Comal County Environmental Health OSSF Inspection Sheet

Permit of Authorization to Construct an On-Site Sewage Facility Permit Valid For One Year From Date Issued

5926 COLIN RDG
NEW BRAUNFELS, TX 78132

**Re: Theodore Adams Bartling Jr. & Madeline Paige Bartling
Copper Ridge, The Addition North Phase, Lot 53
Application for Permit for Authorization to Construct an On-Site
Sewage Facility (OSSF)**

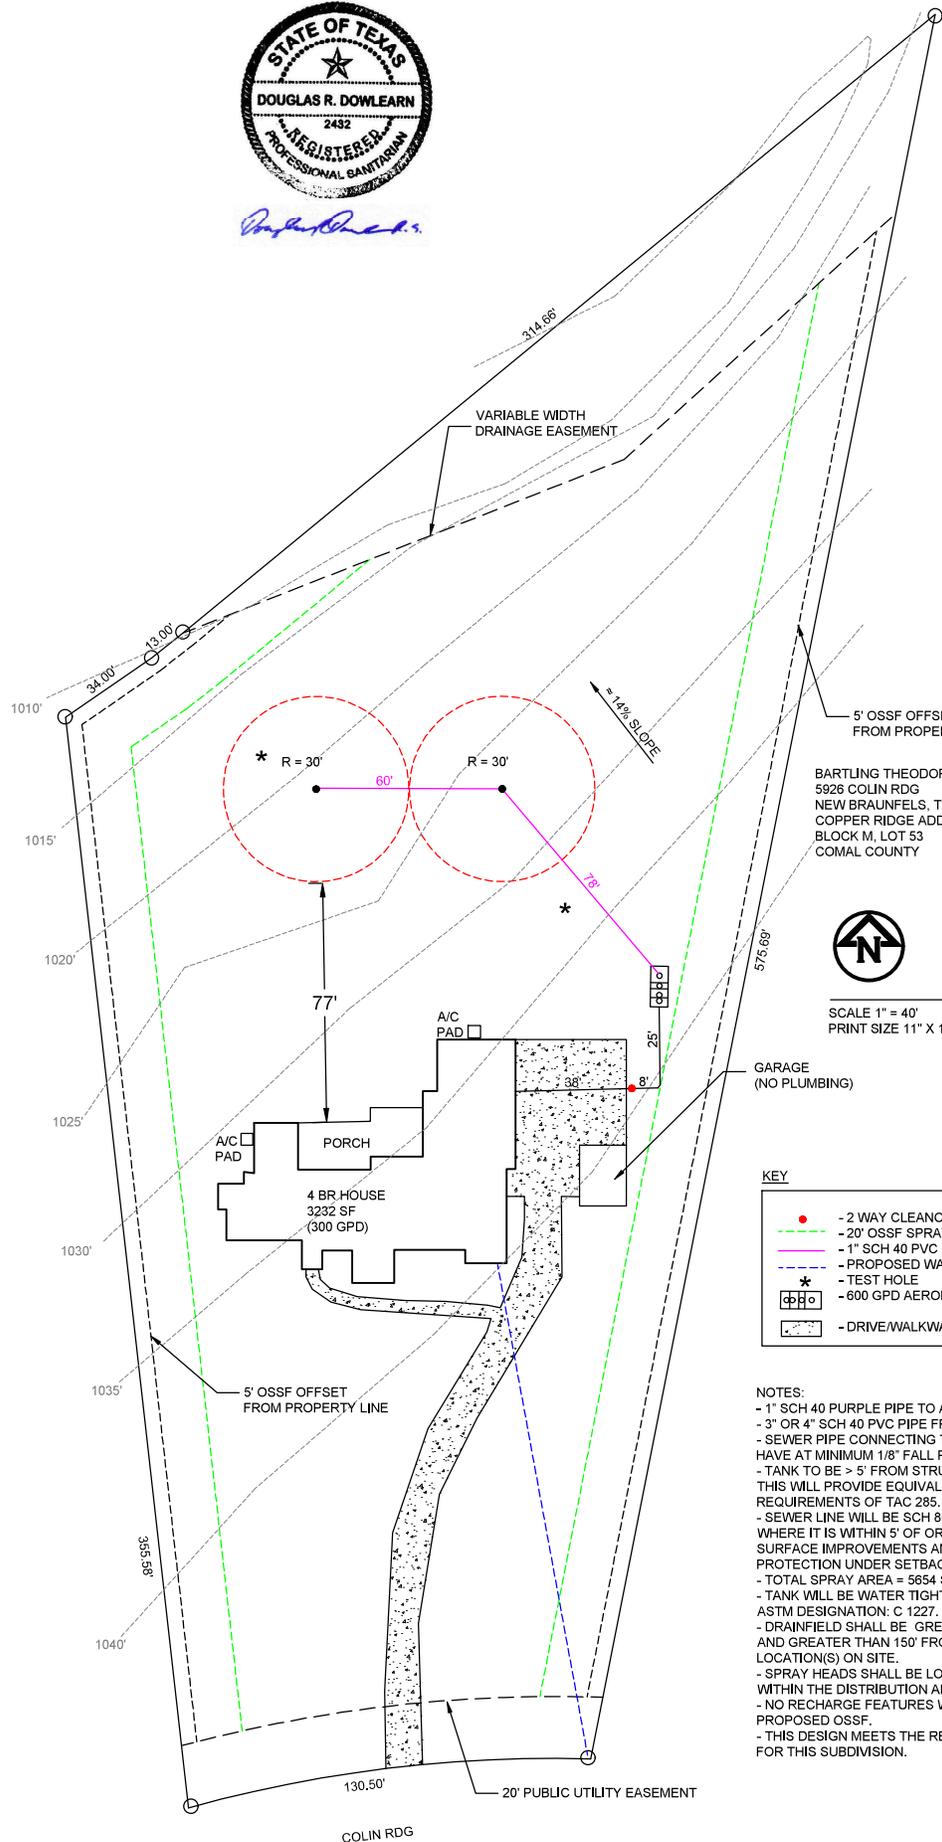
- ✘ Add the gym to the permit application.**
 - ✘ How is the gym connected to the system?**
 - ✔ How will equivalent protection be provided to the clean out within the driveway**
 - ✘ If the gym is for single family use then a notarized affidavit for single family use of both the home and the gym is needed. A sample affidavit form is attached.**
5. **Revise as needed and resubmit.**

- TANK TO BE > 5' FROM STRUCTURES AND SURFACE IMPROVEMENTS. THIS WILL PROVIDE EQUIVALENT PROTECTION FOR THE SETBACK REQUIREMENTS OF TAC 285.
 - SEWER LINE WILL BE SCH 80 PVC OR SLEEVED WITH SCH 40 PVC WHERE IT IS WITHIN 5' OF OR CROSSES UNDER DRIVE, WALKWAY, SURFACE IMPROVEMENTS AND 5' BEYOND TO PROVIDE EQUIVALENT PROTECTION UNDER SETBACK REQUIREMENTS OF TAC 285.
